Farview Farms Resubdivision

Sherman, Connecticut

Environmental Review Team Report

July 2005

Figure 2 Part of Sheet 7 of Site Development Plan showing on Lot 12 the meltwater channel (col) and the inferred direction of water flow through the channel (col).

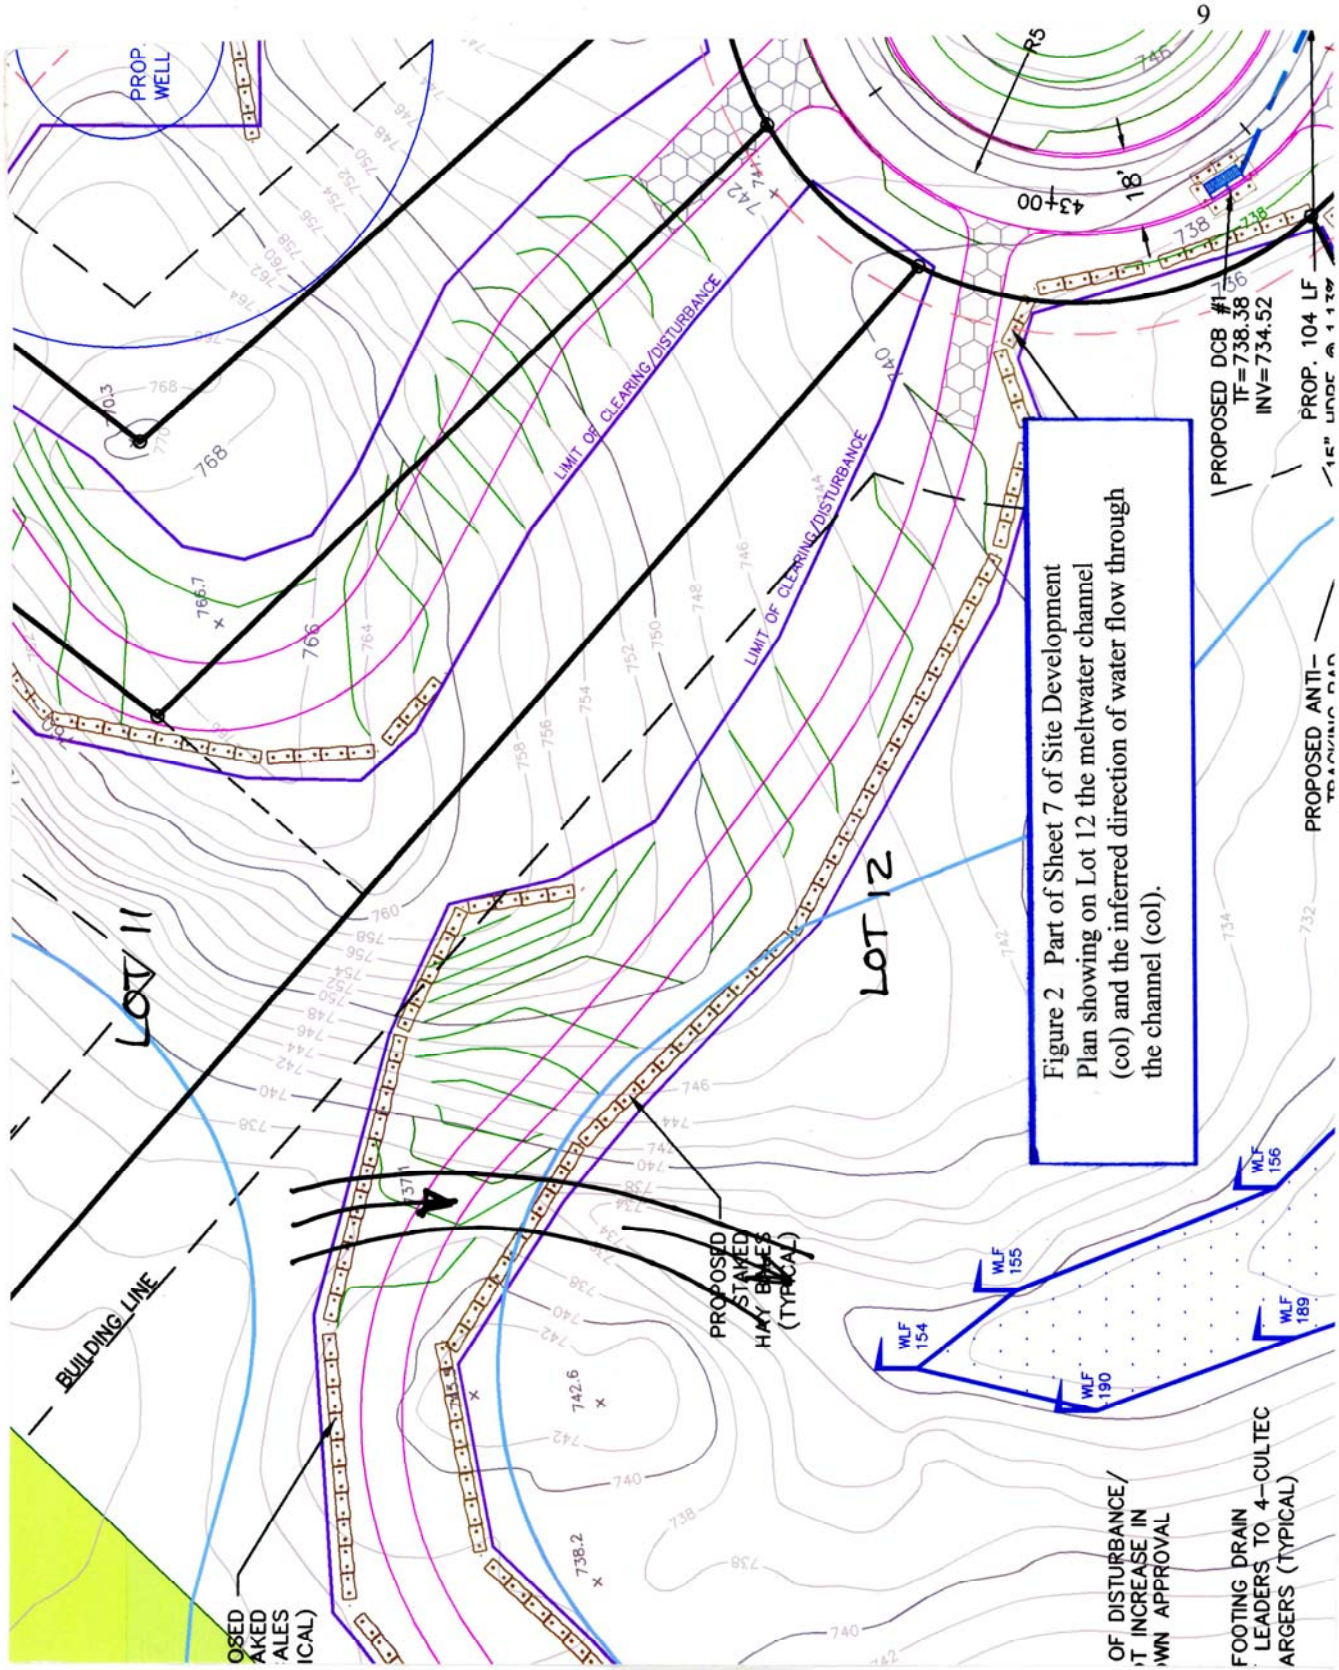
An unusual feature was noted on Lot 12 (Figure 2) where a proposed driveway comes off the cul-de-sac turnaround and crosses a shallow bedrock col that is on the drainage divide between the drainage basins of Wimisink Brook and Deuel Hollow Brook. The ledge exposed in the col has smooth water-worn features that suggest at one time torrents of water cascaded through the low spot in the ridge traveling from north (west) to south (east). The water was likely derived from melting ice age glaciers and could only travel up and over the divide if a melt-water stream flowed on or beneath remnant glacial ice. It is unfortunate that the proposed plans call for grading the bedrock (requiring blasting) and filling the col to accommodate the driveway.
